EAGLE MOUNTAIN PLANNING COMMISSION MEETING

July 25, 2023, 5:30 PM

6.C [ACTION ITEM -- PUBLIC HEARING: SITE PLAN APPROVAL OF A TO Z
BUILDING BLOCKS ADDITION](#)

TITLE: ACTION ITEM -- PUBLIC HEARING: SITE PLAN APPROVAL
OF A TO Z BUILDING BLOCKS ADDITION

Figure 1 - Examples

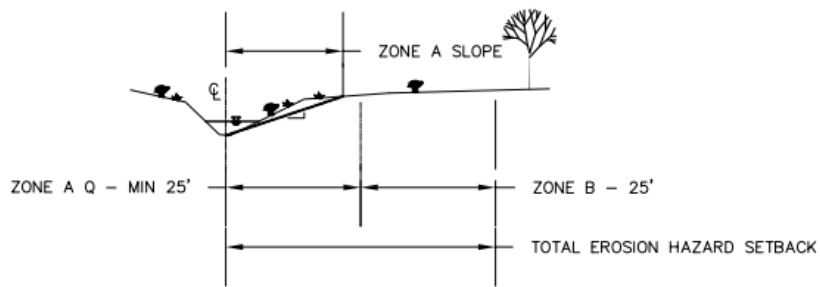
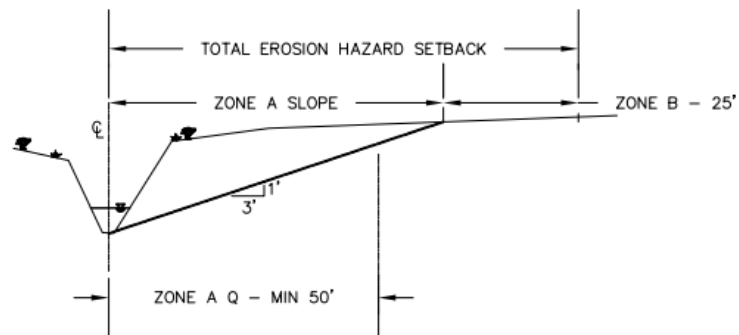
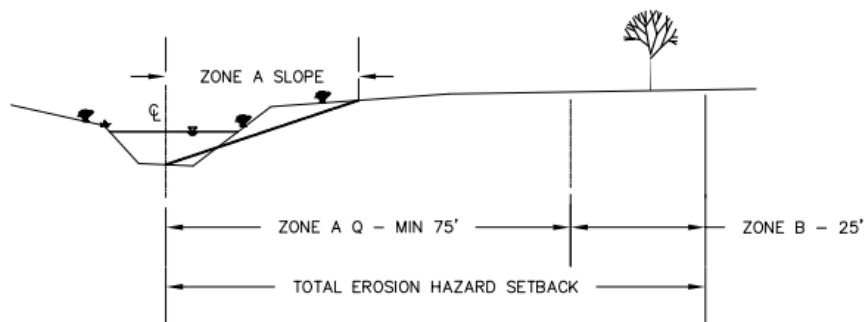
The total EHS will consist of a Zone A distance and a Zone B distance. Zone A is determined by the maximum value based on anticipated flow or slope ratio of 3:1 from the center of the waterway channel. Zone B is a distance of 25 feet. The anticipated flow is based on the Q_{100} for the given waterway and is divided into 3 ranges as shown in Table 1 below. Q_{100} is the flow anticipated in a storm event that has a 1% chance of being exceeded in any given year, some agencies have referred to this in the past as a 100-year storm event. See Figure 1 for examples below.

Table 1: Minimum Zone A Setback

Q_{100}	Distance
<200 cfs	25 feet
200-1000 cfs	50 feet
>1000 cfs	75 feet

2
A201 1/4" = 1'-0"

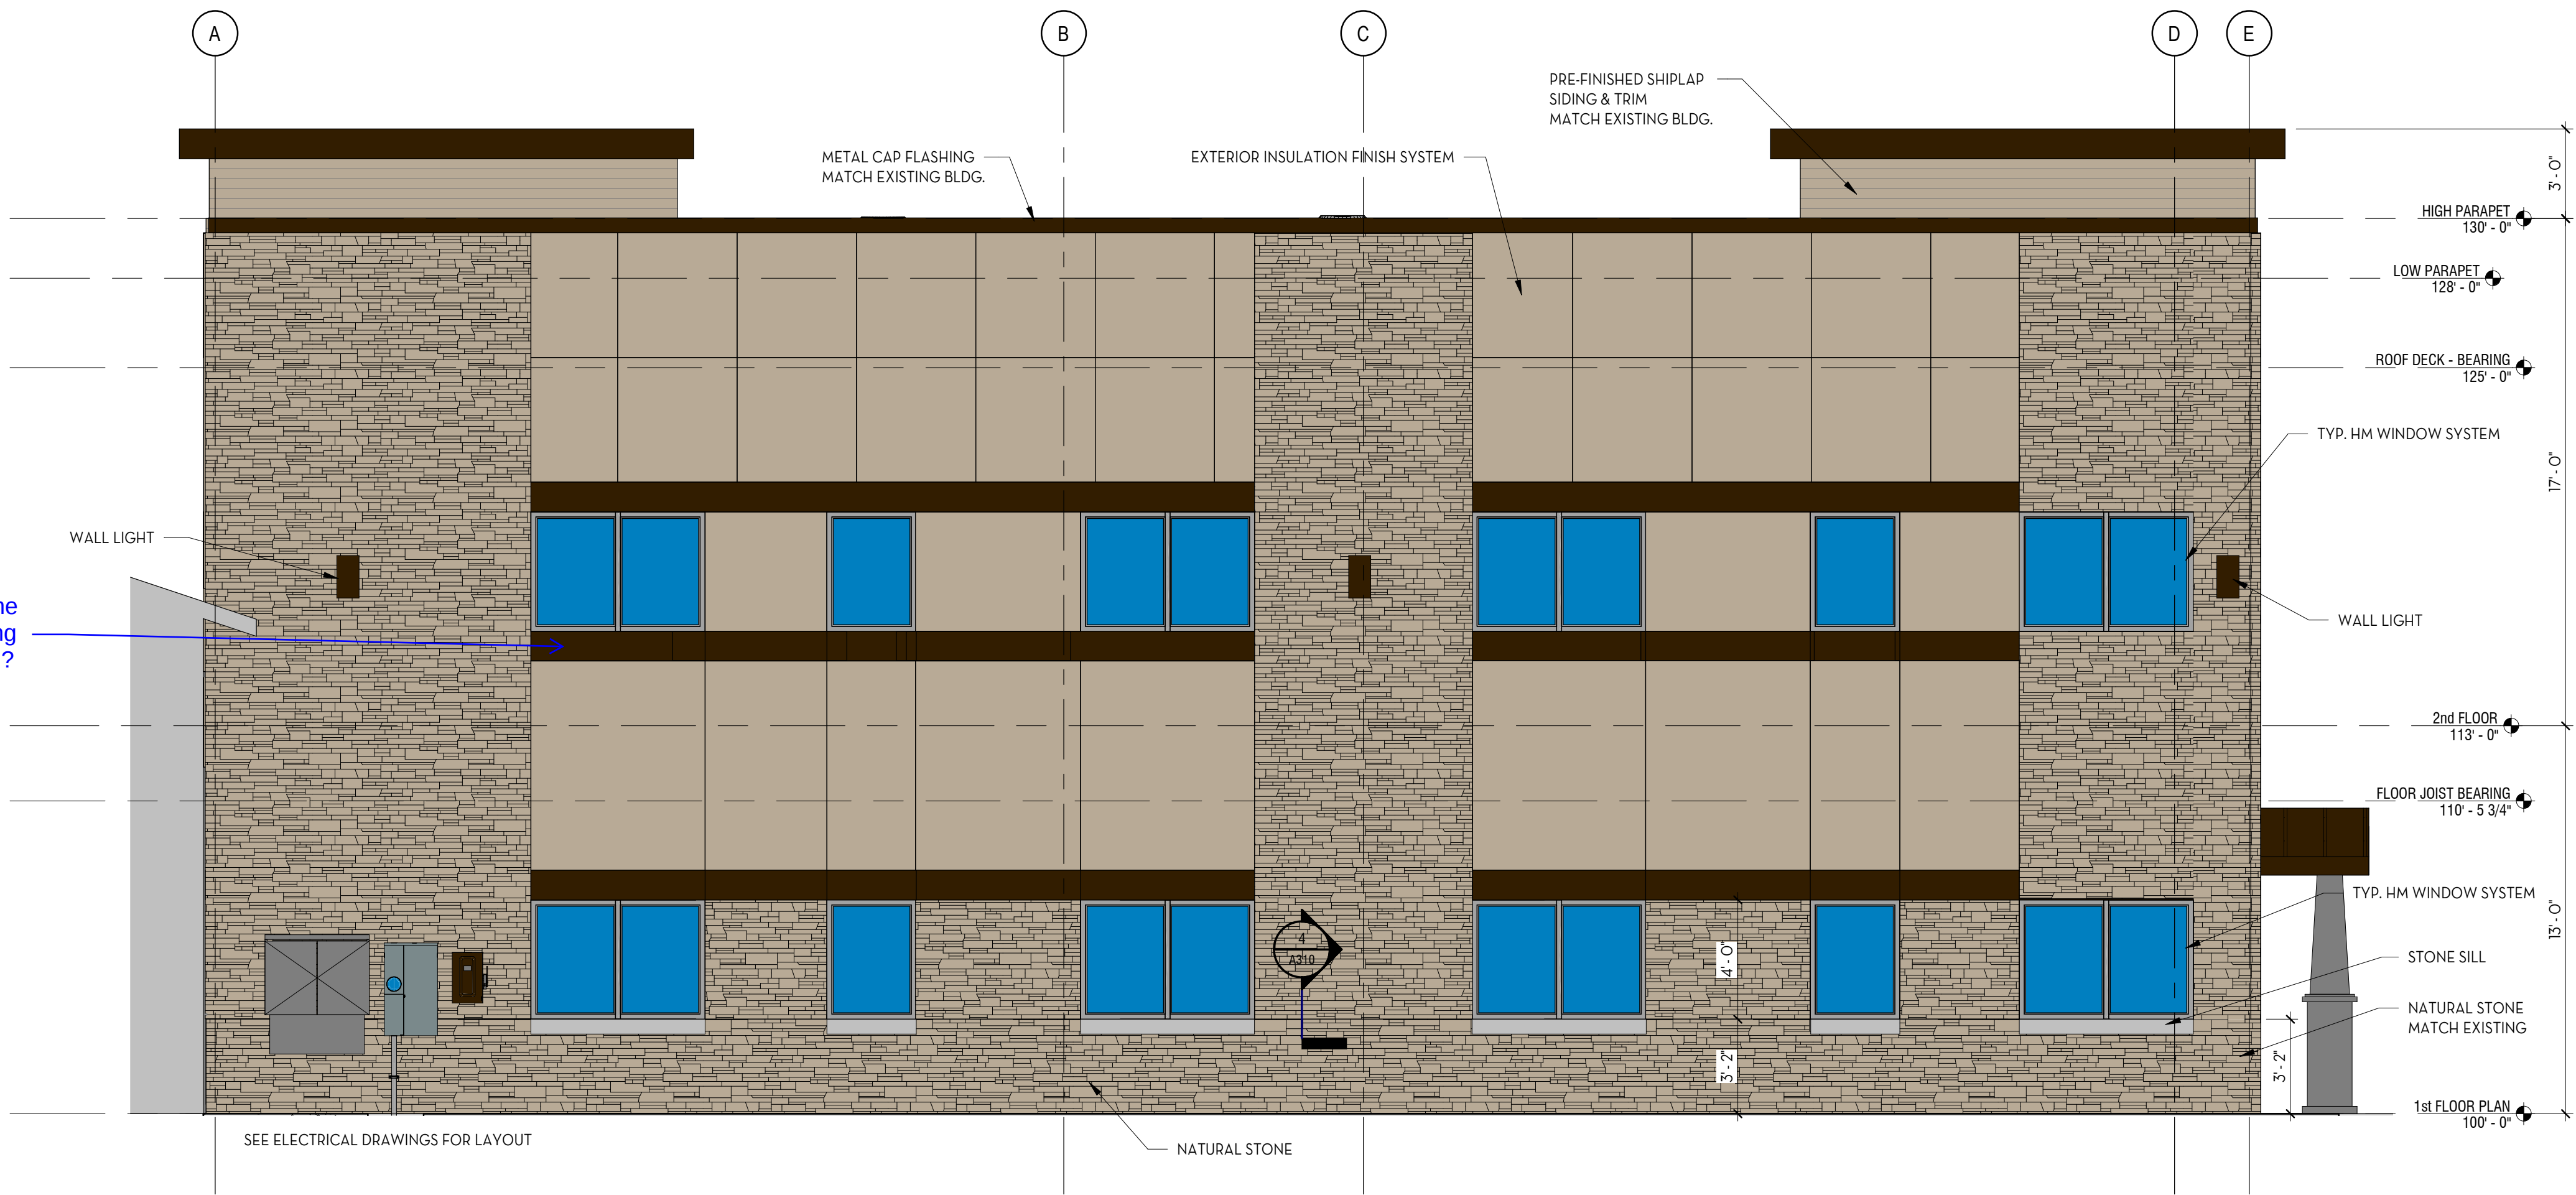
The prior elevations that were approved had more architectural details than the current proposal. The Planning Commission and City Council may want to see details equal to or greater than what was earlier approved. (Repeat comment)

Please provide details on all materials used, or state that all materials will match the existing building. (Repeat comment)

EMMC 17.72.040 D. Building Articulation. Vertical and horizontal articulation and relief reduces the perceived scale of buildings. Buildings shall include facade modulation (stepping portions of the facade), horizontal and vertical divisions (textures or materials), window patterns, offsets, recesses, projections, varied front setbacks or staggered and jogged unit planes within the same structure, and other techniques to help identify individual residential units in a multifamily structure, and to avoid large, featureless and/or paneled surfaces on commercial buildings. Large uninterrupted expanses of a building wall are prohibited. (Repeat comment)

Is this material the metal cap flashing or the siding trim?

2 SOUTHWEST ELEVATION
A202 1/4" = 1'-0"

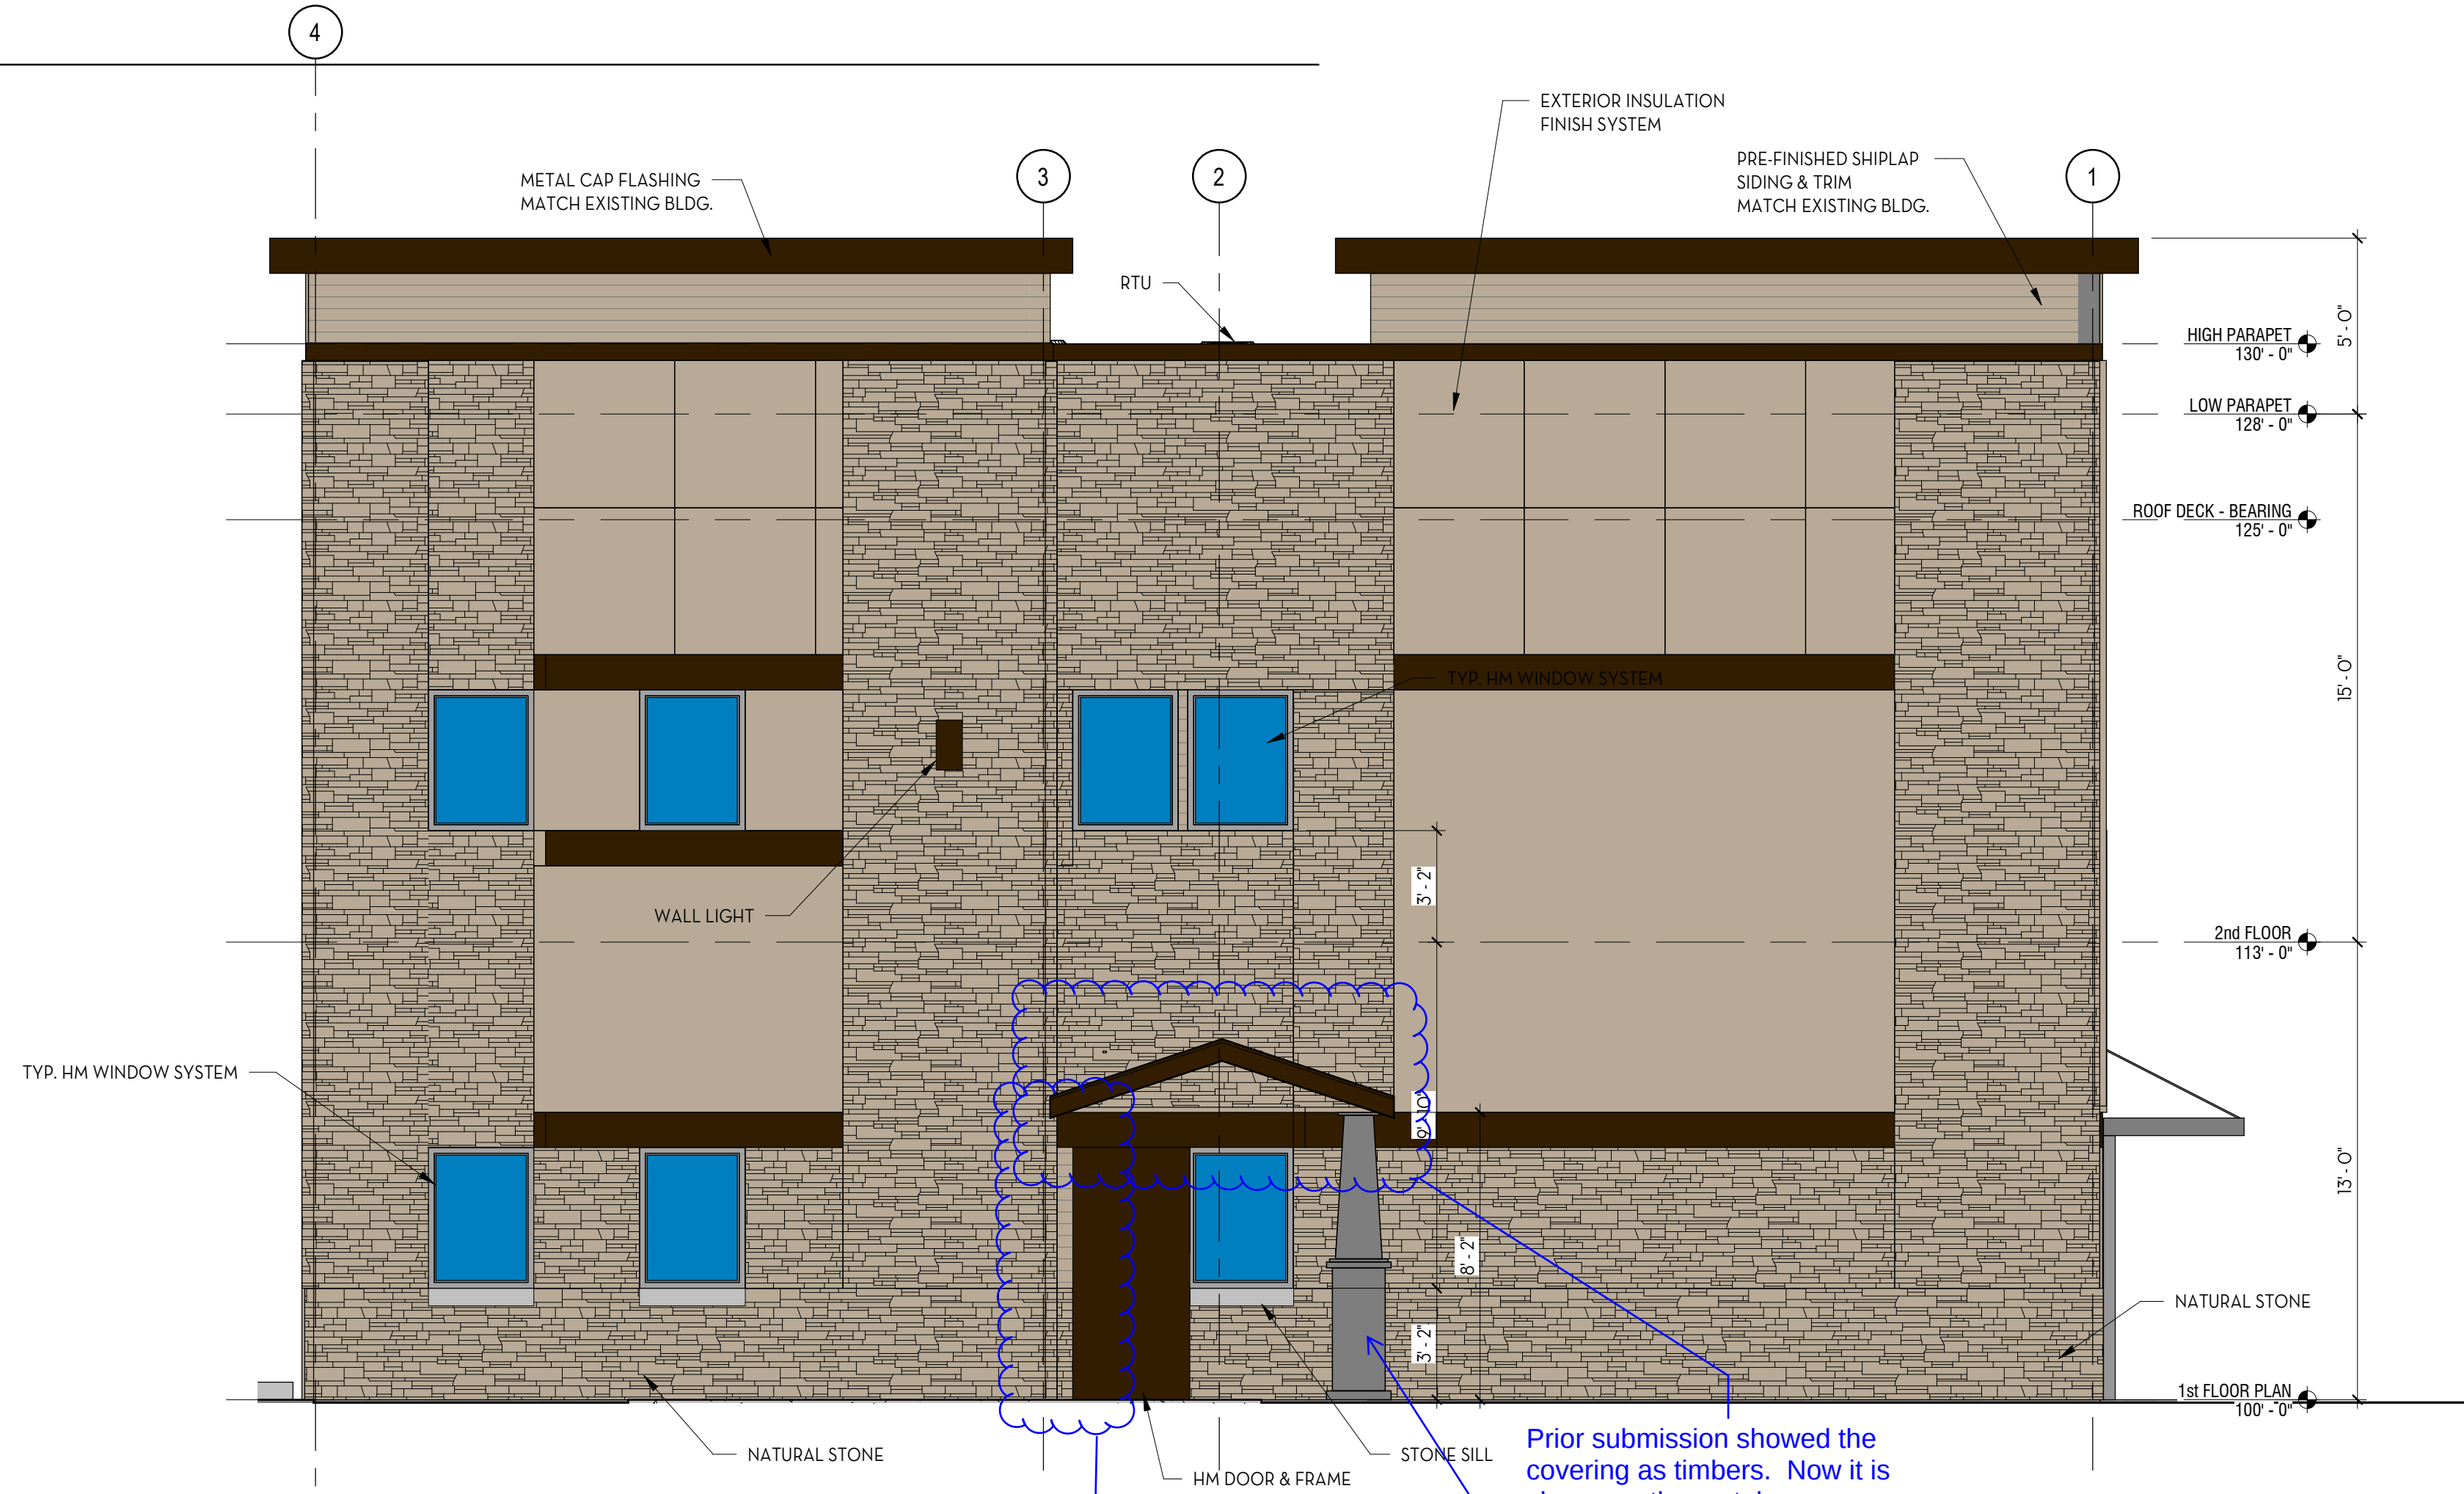
Earlier submitted elevations had a pillar here. Consider adding it back in to better match the existing entrance.
